Studebaker

SERVICE BULLETIN

NO. 315

1956

FIG. 1

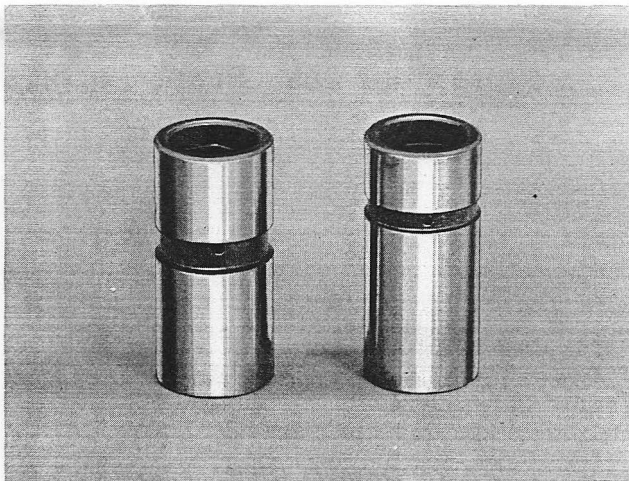
The new valve lifters, having the greater oil reservoir, have a narrower oil groove in the body and the groove is raised slightly as shown by the right hand lifter in Fig. 1.

FIG. 2

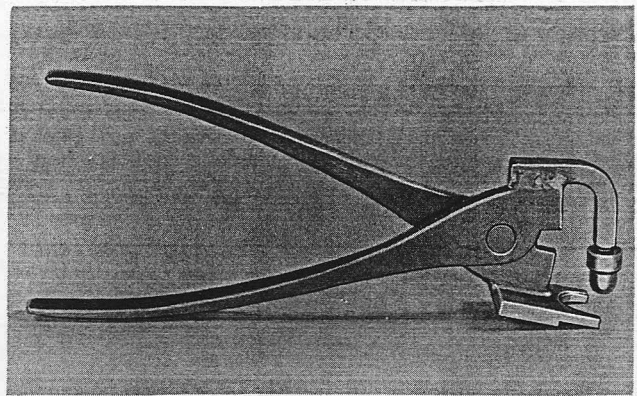
The Hydraulic Valve Lifter Checking Tool J-5978 has been revised by Kent-Moore so that the tool can be used for both the early and the later type hydraulic valve lifters. The original tool J-5978 has now been substituted by J-5978-A.

Figure 2 illustrates the new tool J-5978-A that will test either type lifter.

FIG. 3

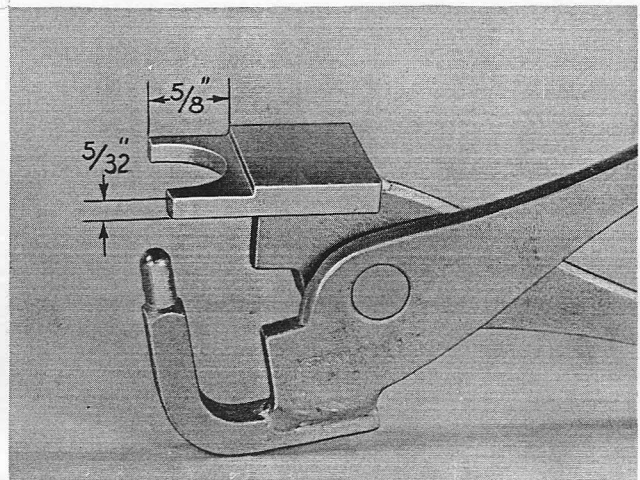
The J-5978 Checking Tool can be modified so that it can be used on the later type lifters by grinding down the lower jaw of the tool as shown in Fig. 3 and using an Adapter Kit J-5978-6 (see Fig. 4). Grind the two ears of the lower jaw down to a $5/32$ " thickness and back $5/8$ " as shown.

FIG. 5

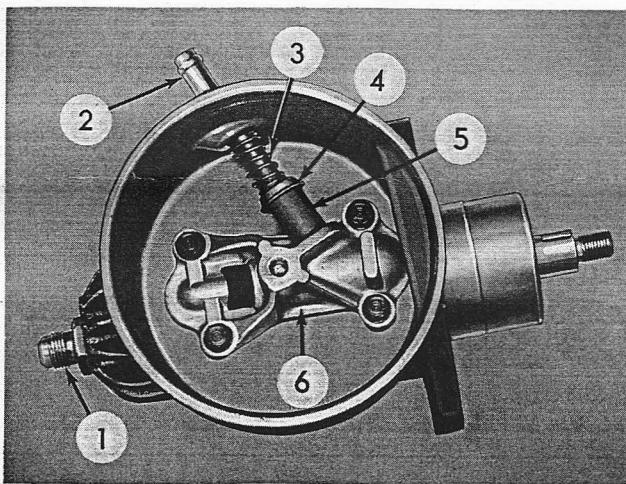
The new pump has more volume throughout the range. It differs in construction from the previous pump and most of the service parts are not interchangeable, but the disassembly procedures are essentially the same. The new pump

assembly can readily be identified because the hydraulic return hose is attached to a tube in the reservoir, rather than to the pump cover assembly. Further, the return hose no longer uses high pressure fittings; it is assembled with wrap-around hose clamps. This pump has a small screen (5, Fig. 5) located in the reservoir to filter the oil as it is returned.

The return tube (2) attached to the reservoir is shorter on the assemblies used on the 56G - W-F-D models than the tube of the unit used on the other models. This is necessary to prevent interference between the return hose and the battery. The unit as received from the Parts Depot will have the longer tube. Therefore, it will be necessary to modify the tube before it is used on the 56G - W-F-D models. Before installation, cut off approximately 1/2" of the tube, using a tube cutter. Every precaution should be taken to prevent chips or foreign matter from entering the return tube.
